Supplement to the Imperial Valley Solar (formerly Solar Two) Application for Certification

Application for Certification (08-AFC-5) Imperial Valley Solar, LLC

Subject: Imperial Valley Solar (formerly Solar Two) (08-AFC-5)
Supplement to the Application for Certification
URS Project No. 27657106.00806

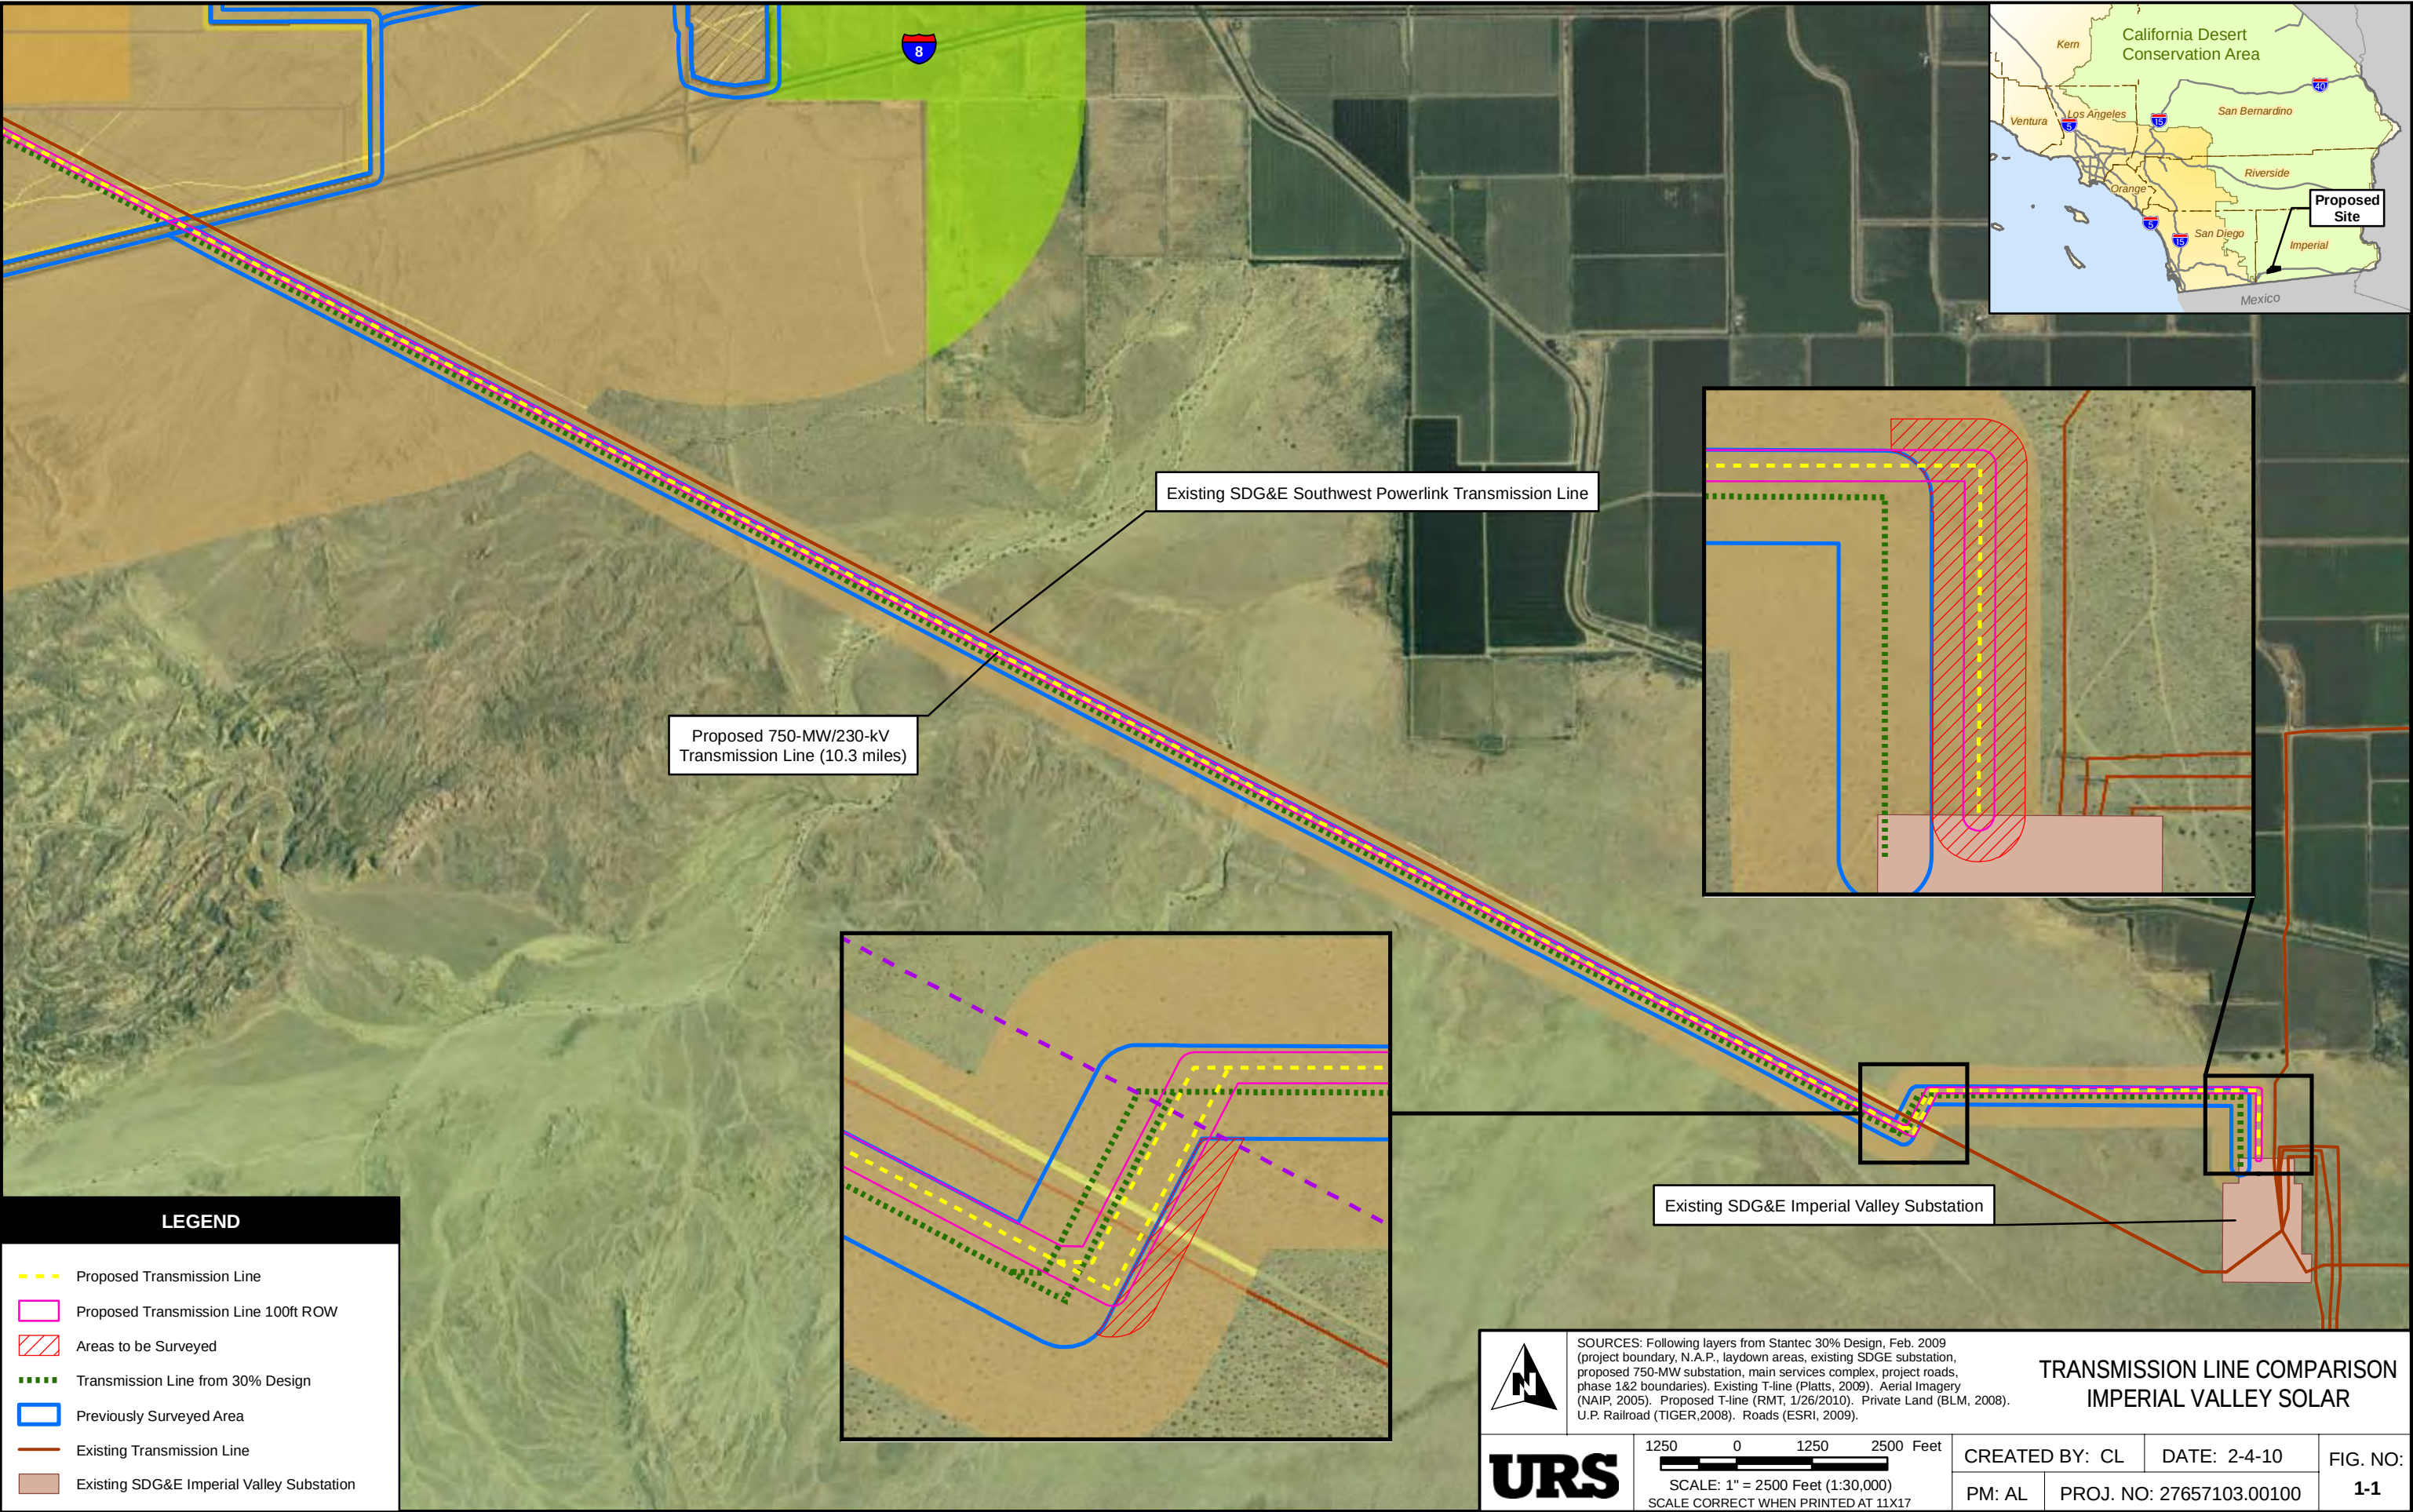
The transmission interconnection to the electrical grid was described in Section 3.6 of the Project AFC. Subsequent advances in the engineering for the transmission line have resulted in minor modifications to the alignment (Figure 1-1). San Diego Gas & Electric (SDG&E) requested modifications to the Imperial Valley Solar 230 kV transmission line tie-in to the Imperial Valley substation to accommodate the planned alignment of a new 500-kV SDG&E transmission line and tie-in at the Imperial Valley Substation. Portions of the new alignment would fall outside of the areas previously surveyed for cultural and paleontological resources. The western transmission line alignment modification is 760 feet long and was shifted approximately 120 feet to the southeast (Figure 1-1). The second segment modification is just north of the SDGE Substation. This modified alignment is 1,025 feet long and was shifted approximately 300 feet to the east. This Supplement to the AFC analyzes the impacts of the minor modifications in the transmission line alignment that were not previously identified.

Path: G:\gis\projects\1577\2238980\mx\Waterline_Resurvey_withAccess.mxd, 05/05/10, camille_hill

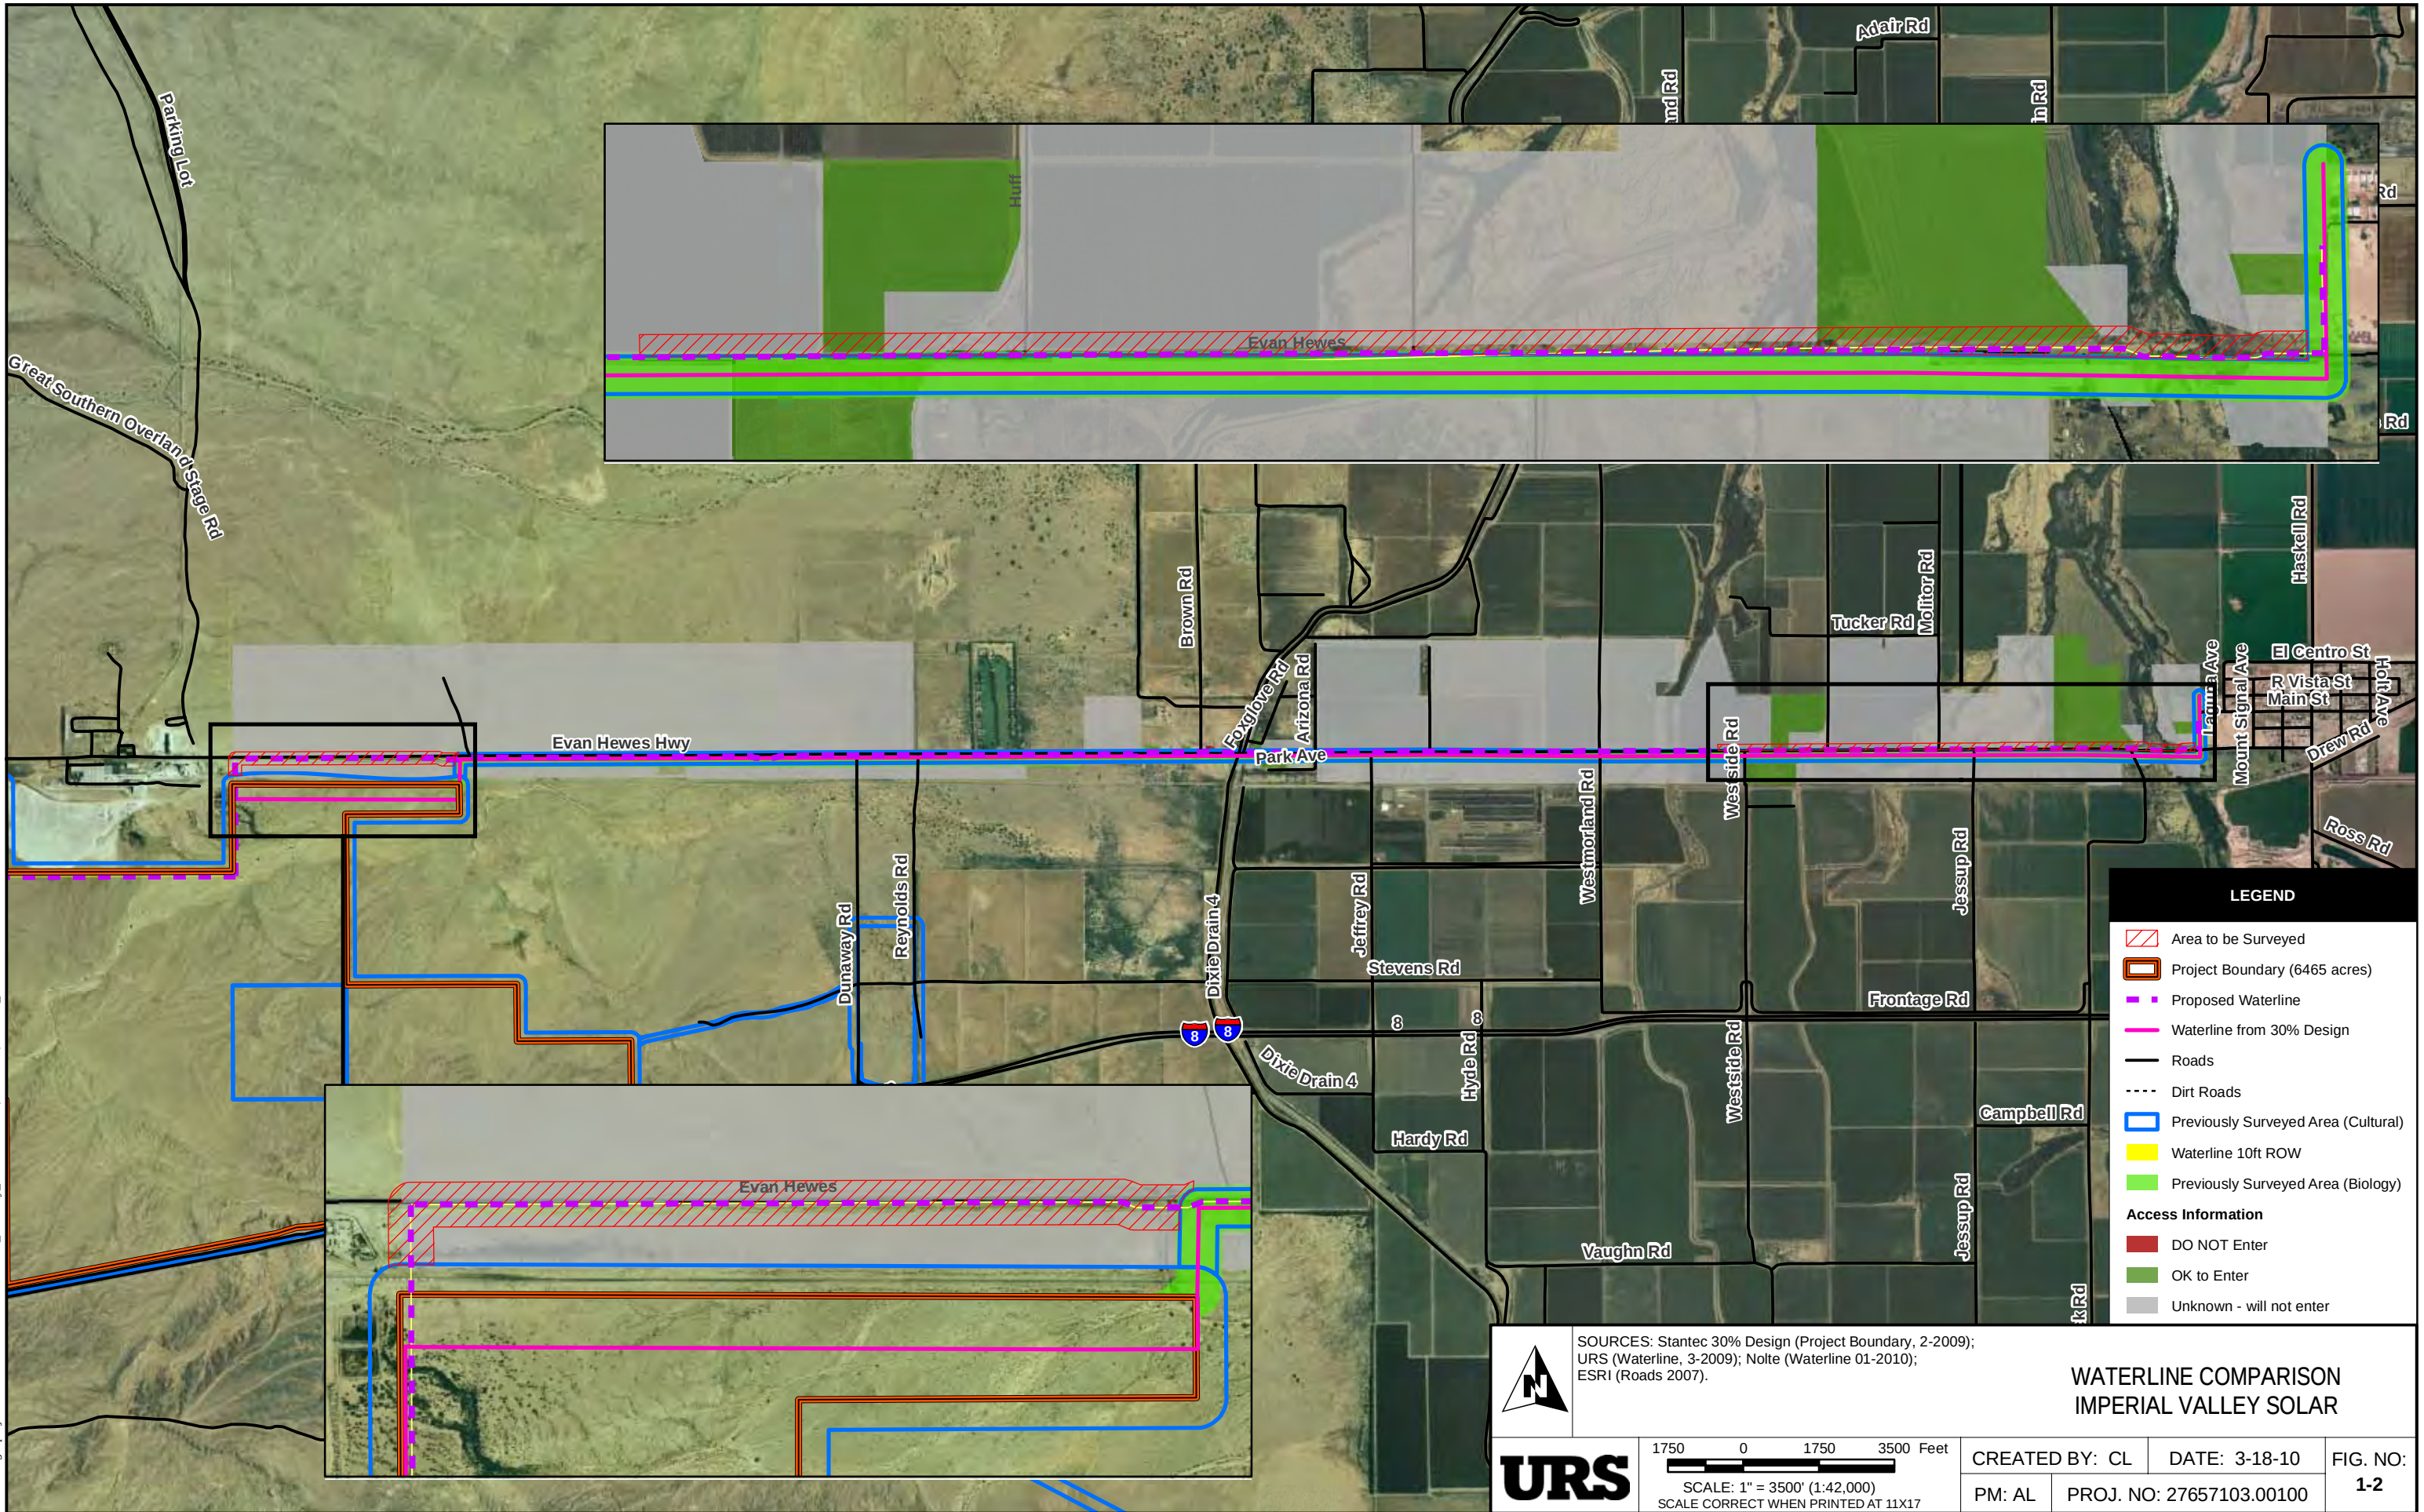
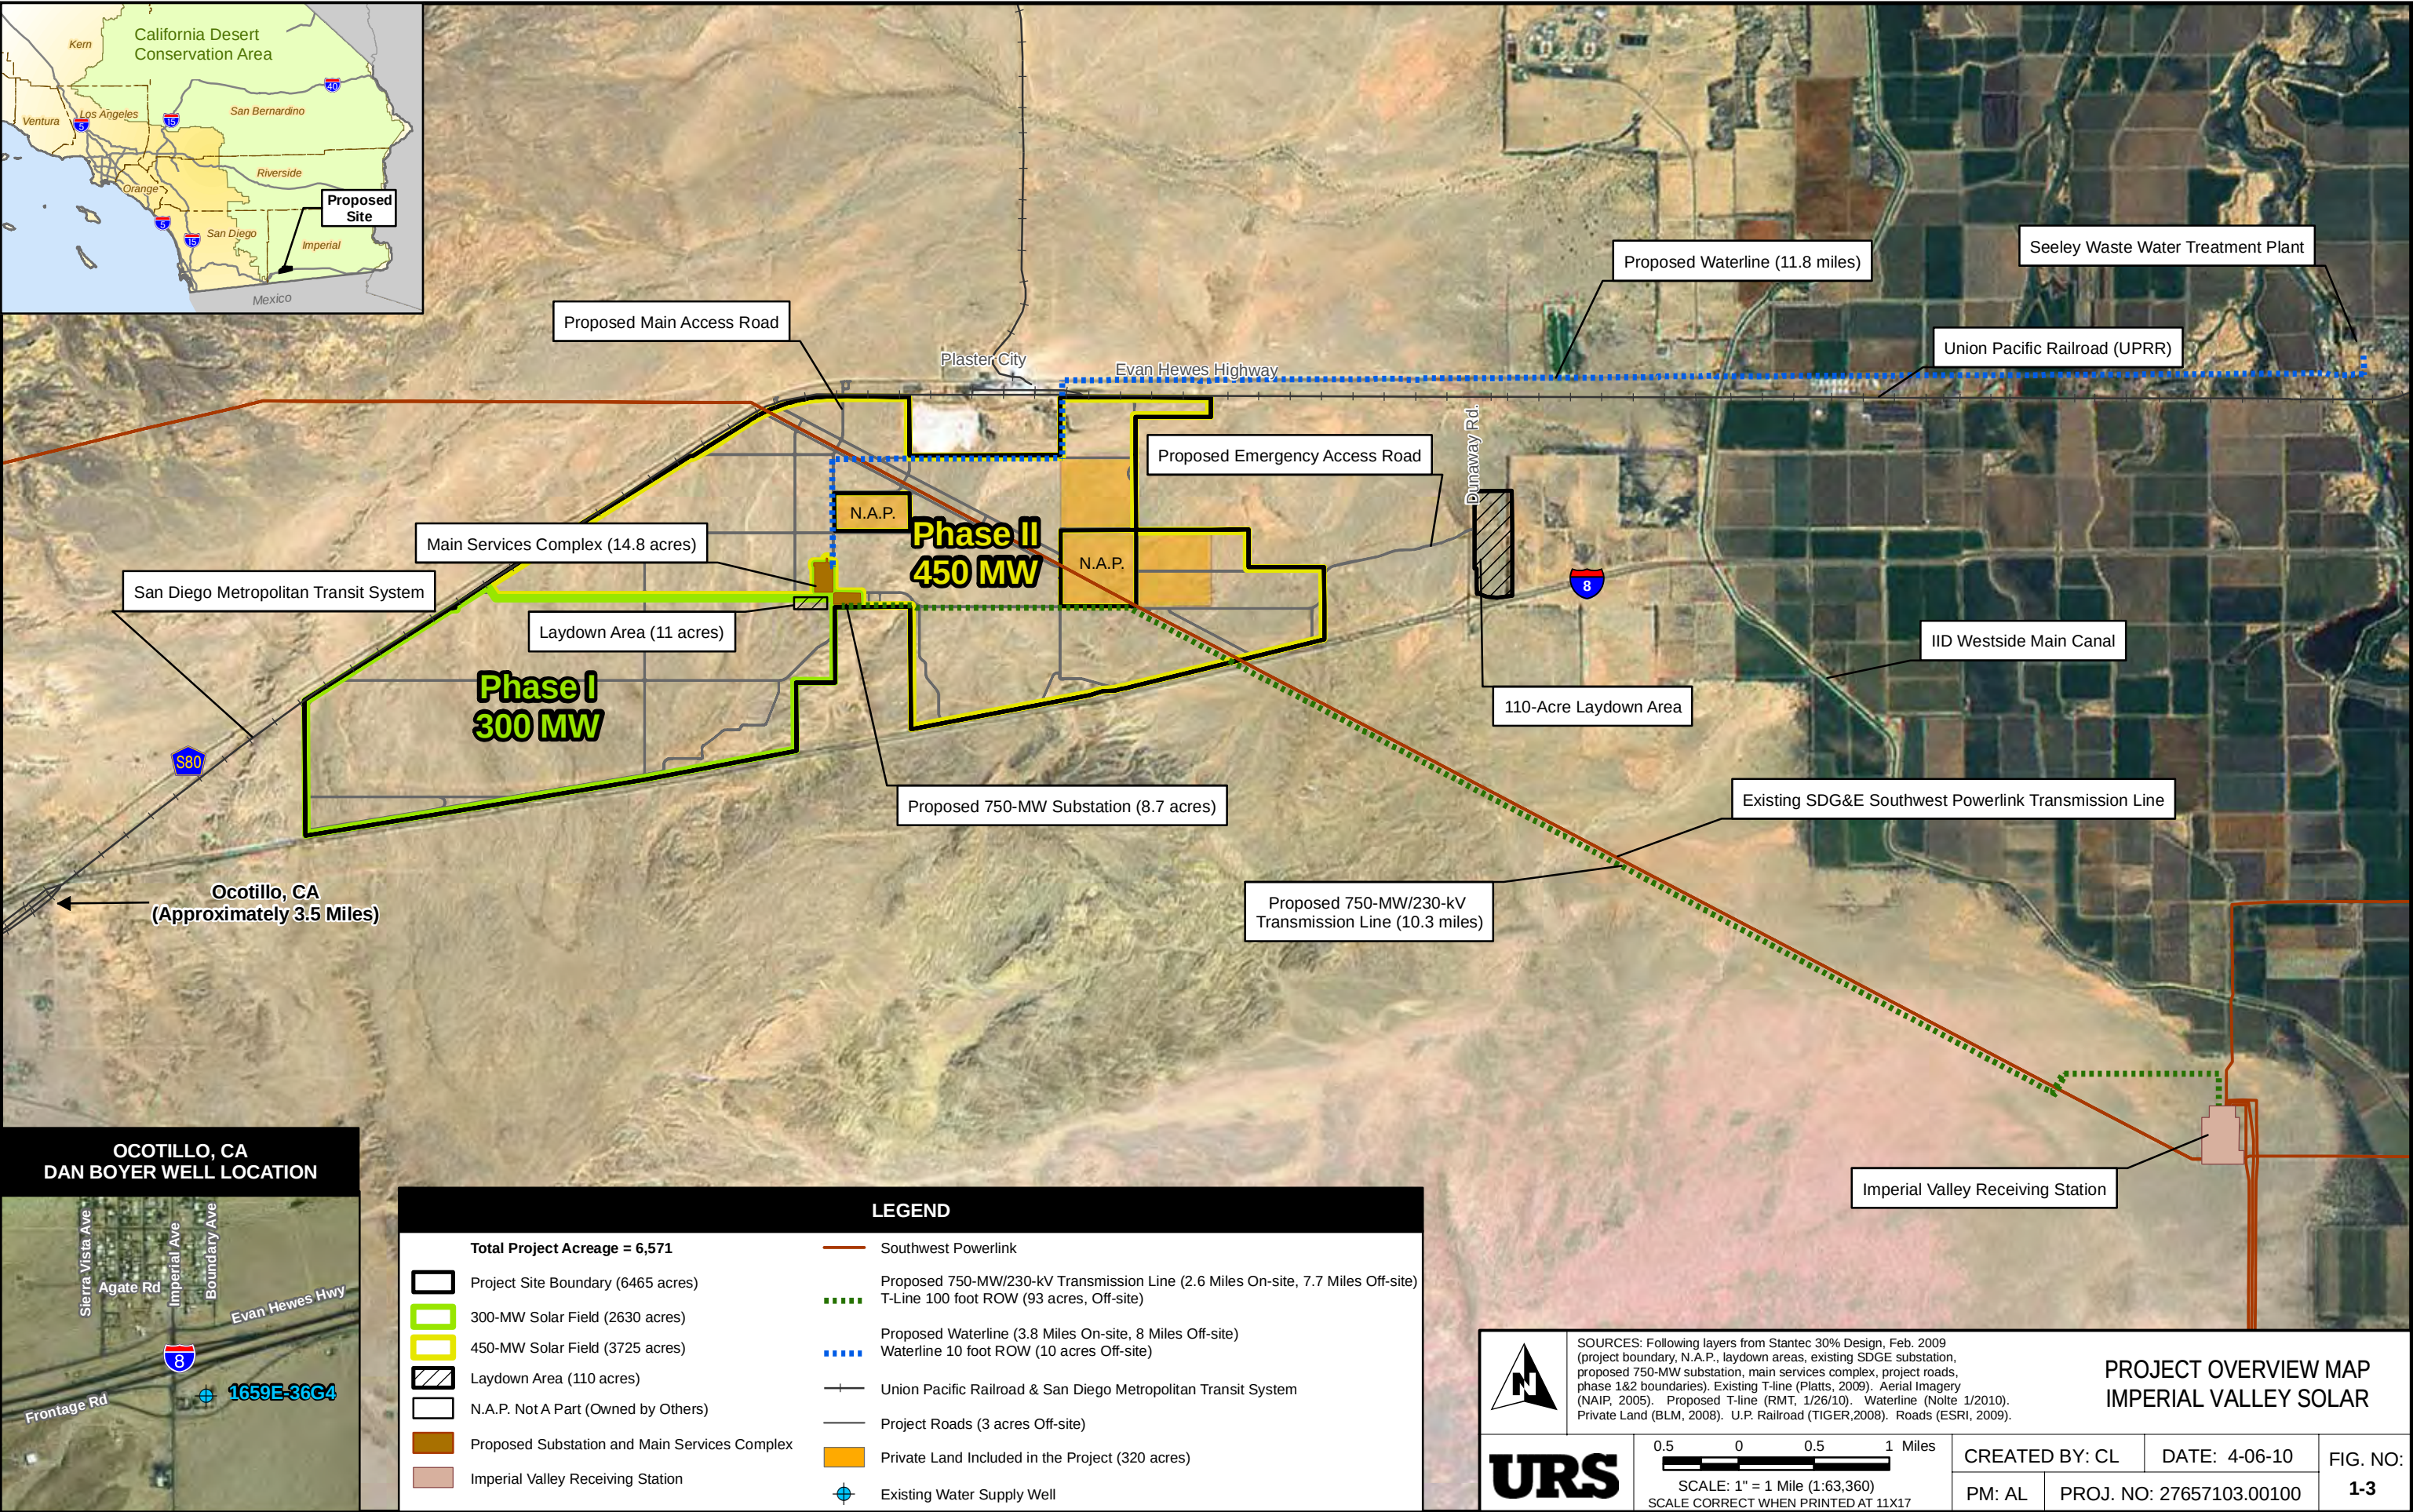
resources. The waterline modifications involve two segments, the longest modification is 300 feet (western modification) and the shorter modification (eastern modification) is approximately 160 feet in length (Figure 1-2).
